© 2010 Mazda Motor of America, Inc.

Subject: 3-4 SHIFT SHOCK	Bulletin No: 05-010/10
	Last Issued: 08/06/2010

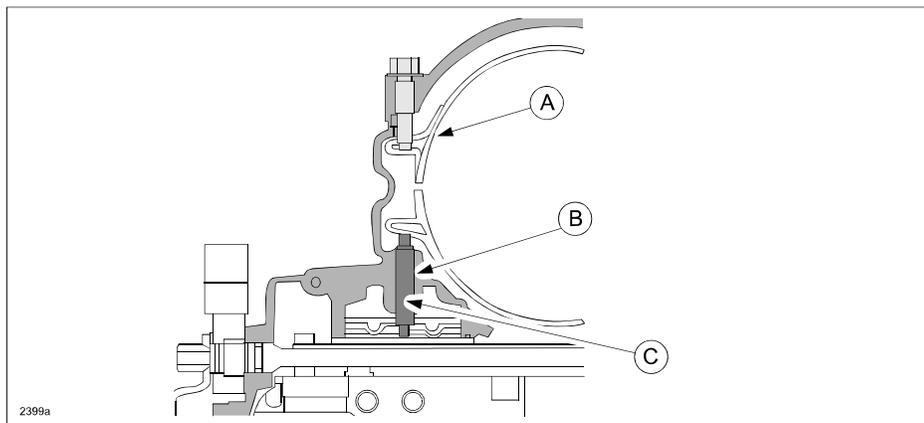
Some vehicles may experience an excessive 3-4 shift shock when driving on an uphill road or with some load applied. Due to uneven wear on the servo piston bore (B), oil leakage from the bore occurs. This in turn causes a mistimed engagement of the 2/4 band (A), resulting in the 3-4 shift shock. To correct the problem, the servo piston (C) hardness has now been changed.

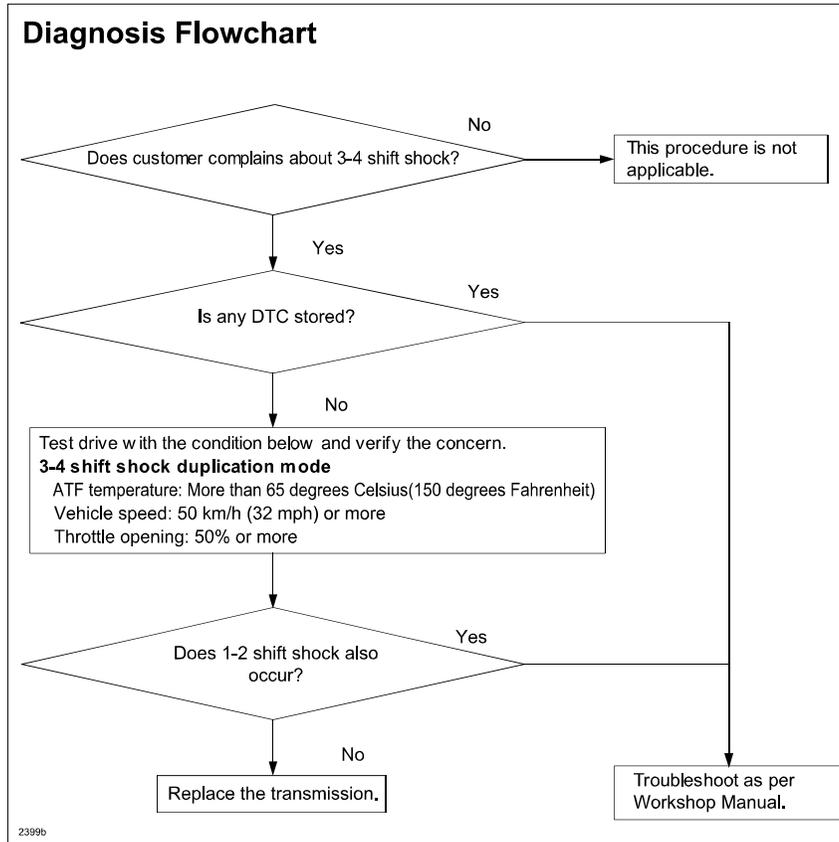
1. Verify customer concern.
2. Follow the "Diagnosis Flowchart" and if the concern seems to be due to wear on the servo piston bore, replace the transmission.

NOTE: Since the servo piston is inside the transmission case, it cannot be fixed with any type of ATF flushing, TCM replacement/reprogram, or valve body replacement.
